MICHAEL ATHANAS & ASSOCIATES
LICENSED SOIL SCIENTIST
1999 CANDLEWICK DRIVE
FORT MILL, S.C. 29715
803-802-4403 (office)
803-802-4402 (fax)

Reference: Data Sheet for Anniston SD, Lot 132
House Footprint: 70' x 80'
Building Setbacks: 35' front/rear, 15' side
Water Source: Private well
Number of Bedrooms: 4/480 GPD
Pre-determined LTAR: 0.3 GPD/FT2 (ICHD) ← Approved by Anthony Coker
Proposed System Type: 25% Reduction
Proposed Repair System Type: LP PBPS
Distribution: Gravity-Drop boxes/end cap
Septic Tank Size: 1000 gallons
Proposed Trench Bottom: 36"

IREDELL COUNTY HEALTH DEPARTMENT

IMPROVEMENT PERMIT / AUTHORIZATION TO CONSTRUCT / OPERATION PERMIT / EXISTING SYSTEM

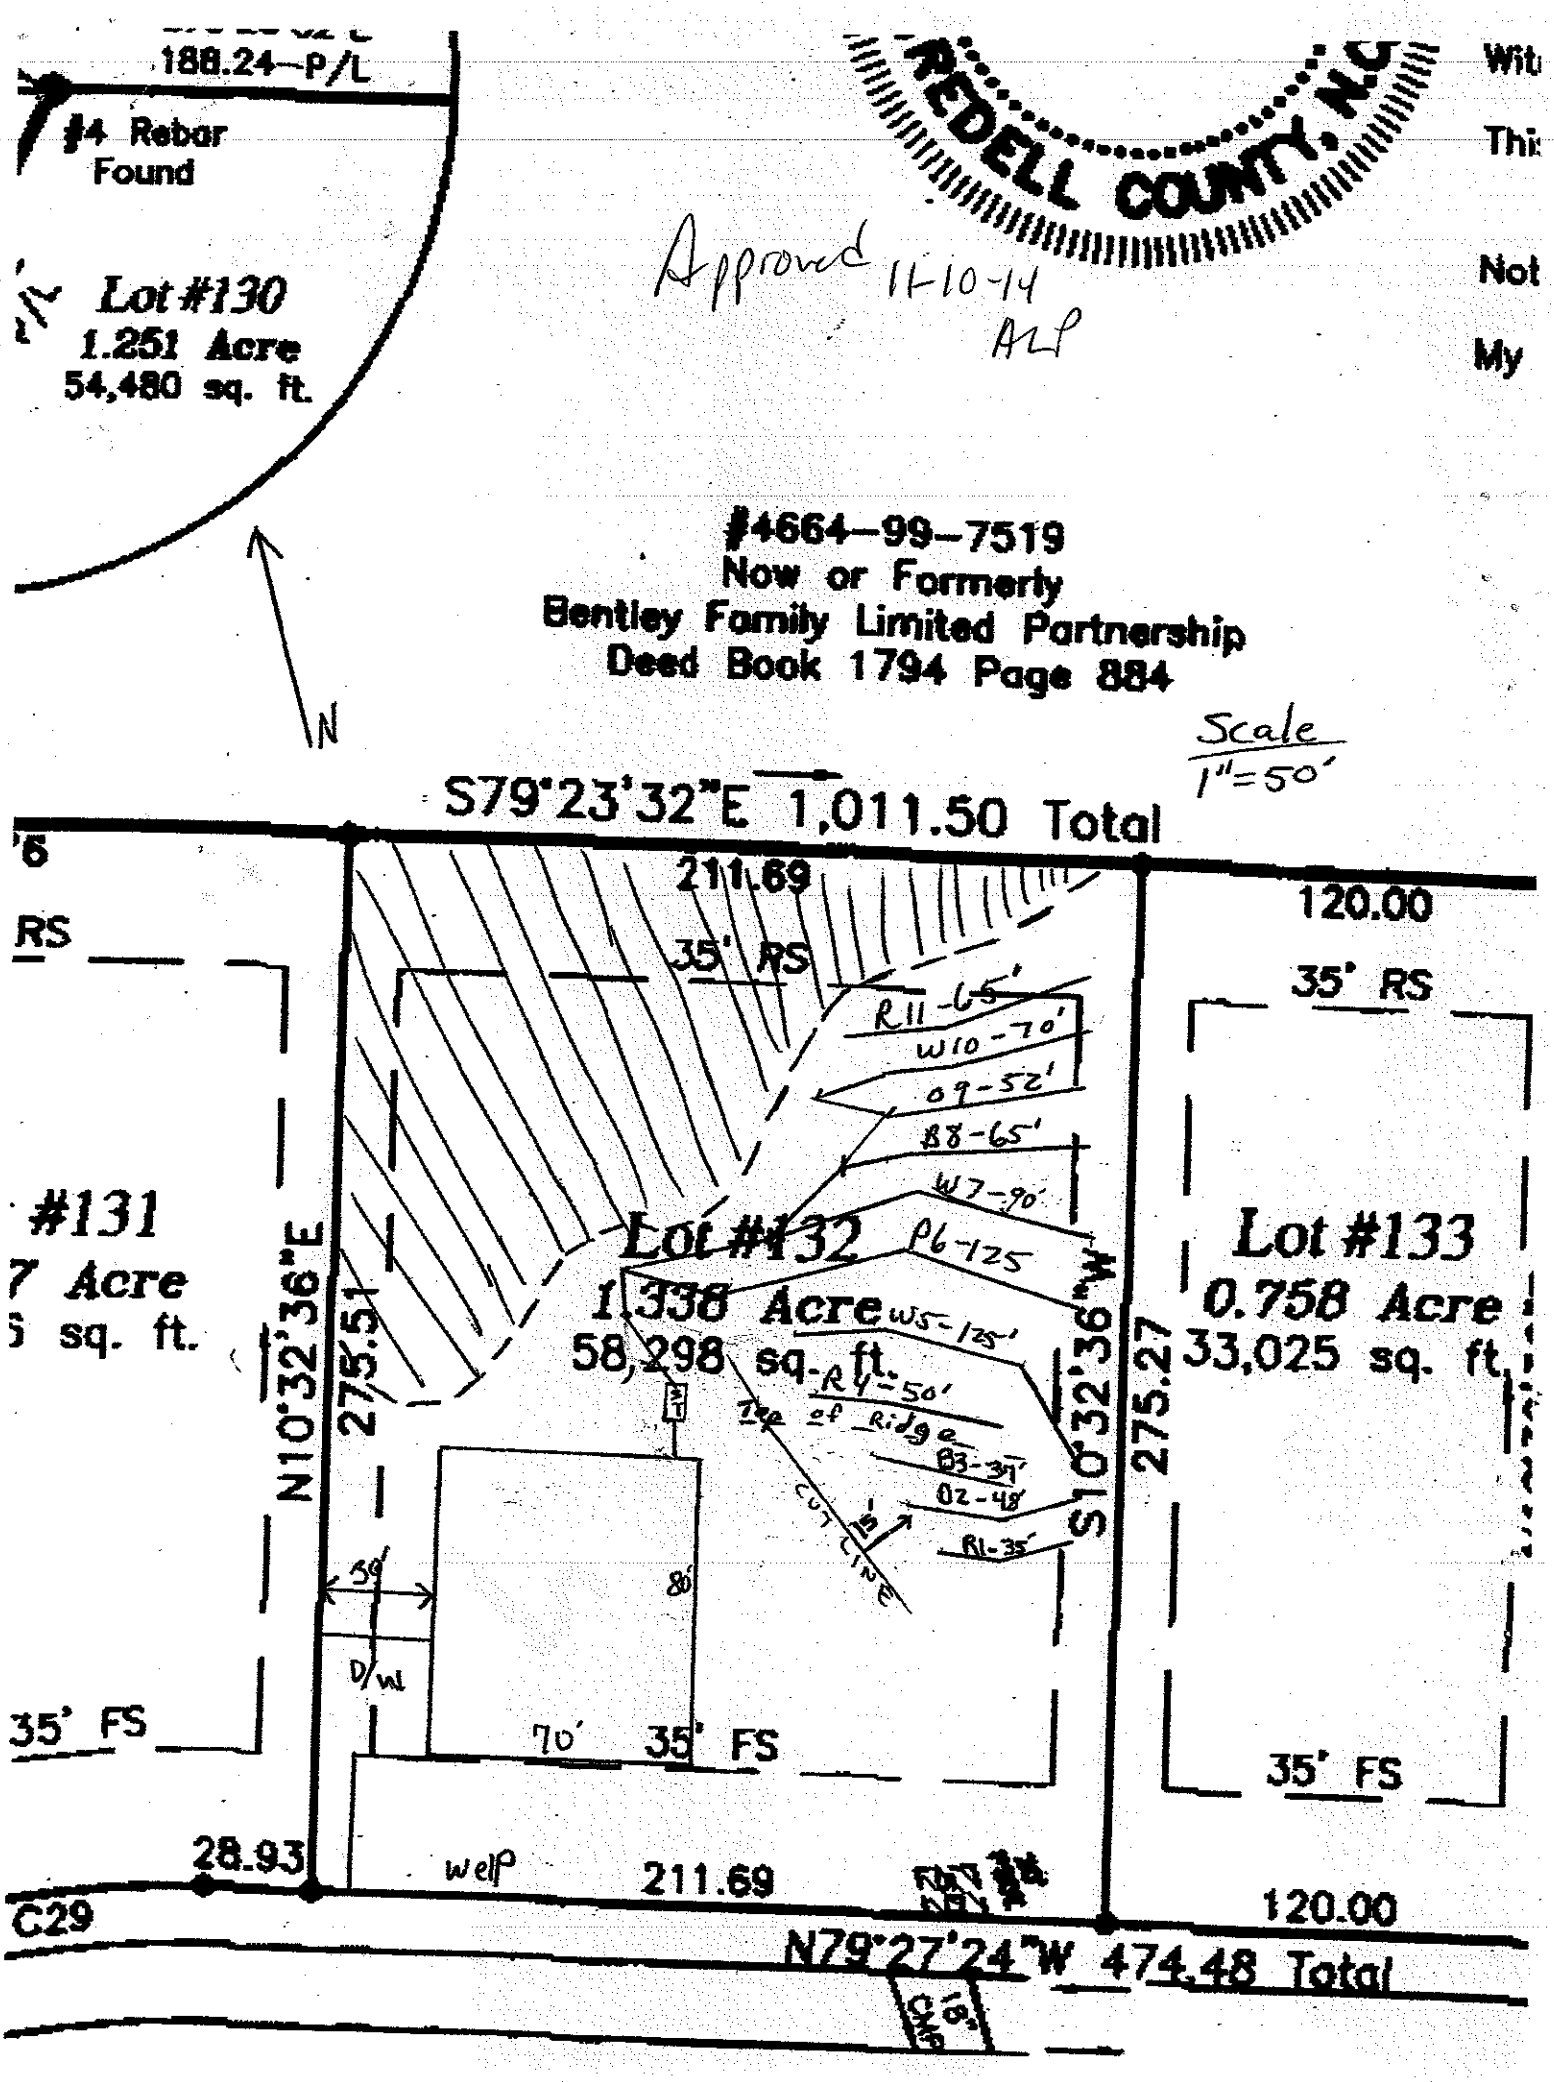
Comments: Currently this lot is permitted as 5 bedroom septic system, due to recent grading activity, we were contacted by Shea Homes to assess the situation. After a field evaluation, there was extensive grading that took place, approximately 2-3 feet was graded off. MA&A has determined the location of the top of the cut, measured 15 feet off and re-measured lines. We have determined that reducing the bedroom count from 5 to 4 that we could still achieve a gravity 25% reduction system with a panel repair. Please note upon our inspection it appeared

the house was outside of the pre-determined house box, therefore we enlarged the house depth by 10 feet on our site plan to accommodate any issues (was 70x70 changed to 70x80). If there are any questions please feel free to contact us. Any changes to this design by ICHD are welcome.

Line	Design Length	Actual Length
Red 1		35'
Orange 2		48'
Blue 3		37'
Red 4		50'
White 5		88'
Pink 6	**125'**	**130'**
White 7	**90'**	**90'**
Blue 8	**65'**	**65'**
Orange 9	**50'**	**52'**
White 10	**70'**	**70'**
Red 11		65'

Initial System: 400' (P6-W10) **Repair System:** 323' (R1-W5, R11)
